MIL-L-3661B
AMENDMENT 4
09 December 1991
SUPERSEDING
AMENDMENT 3
17 February 1972

MILITARY SPECIFICATION

LAMPHOLDERS, INDICATOR LIGHTS, INDICATOR-LIGHT HOUSINGS, AND INDICATOR-LIGHT LENSES, GENERAL SPECIFICATION FOR

This amendment forms a part of MIL-L-3661B, dated 27 March 1967, and is approved for use by all Departments and Agencies of the Department of Defense.

CANDELABRA BAYONET LAMP SOCKETS
FIGURE 1. Moving Contacts

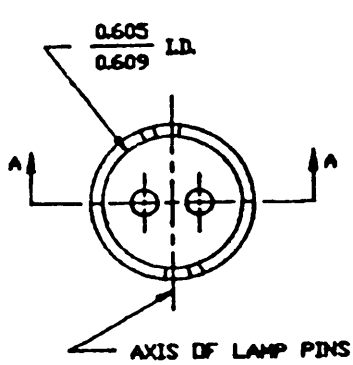
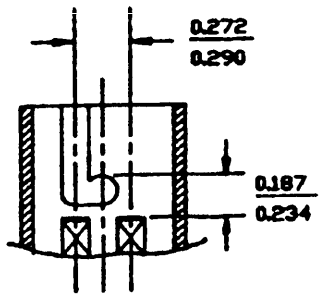
Paragraph 3.4.10.1.1, sixth and seventh lines: Delete and substitute "....sockets, and .187 inch minimum, .234 inch maximum for candelabra bayonet lamp sockets (see figure 1)."

Figure 1: Delete "Candelabra Lamp Sockets" figure and substitute the attached "Candelabra Bayonet Lamp Sockets" figure.

FIGURE 2. Midget and submidget flange base test plugs

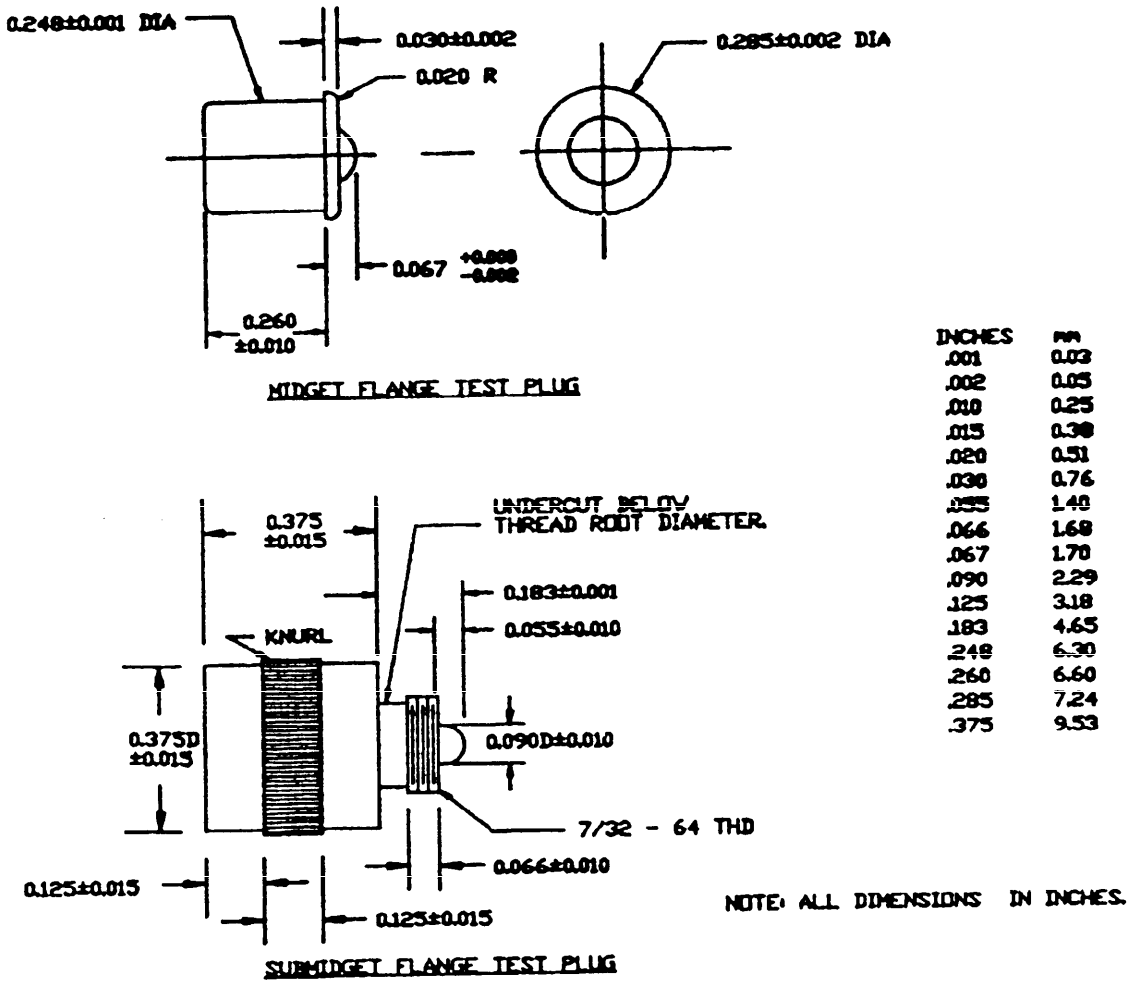
Figure 2: Delete and substitute the attached figure 2.

FIGURE 6. Test plugs for midget and subminiature-flange base indicator light housings (contact spring pressure test).

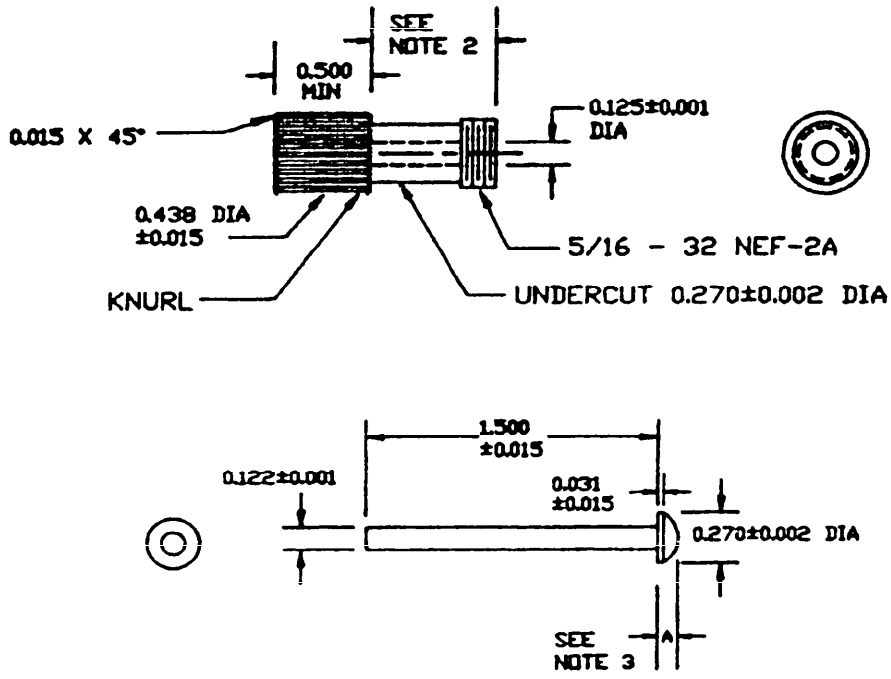
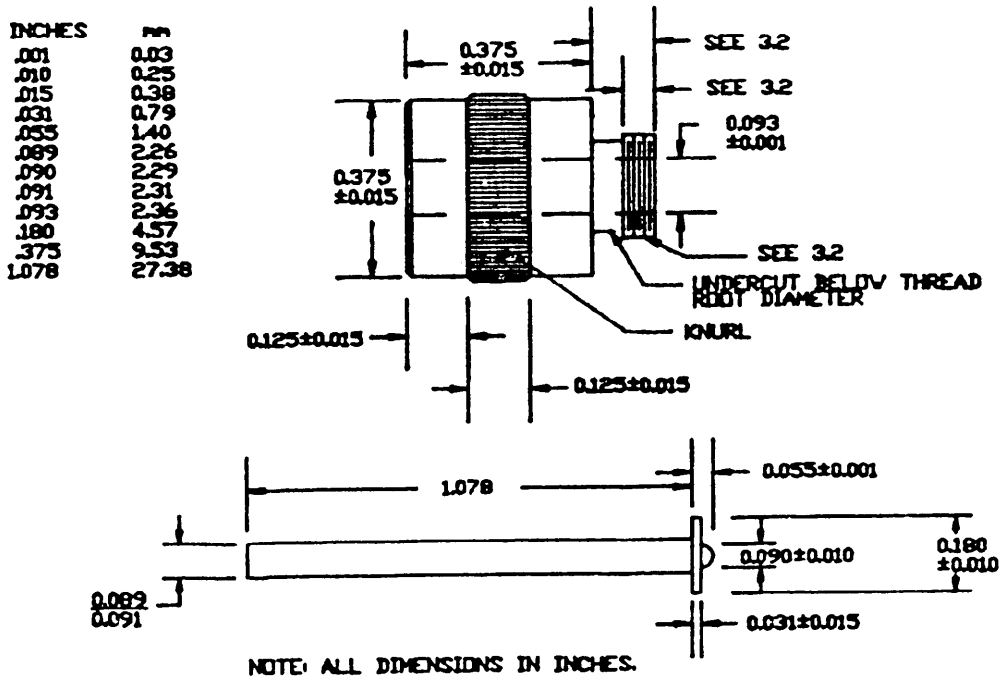
Figure 6: Delete and substitute the attached figure 6.
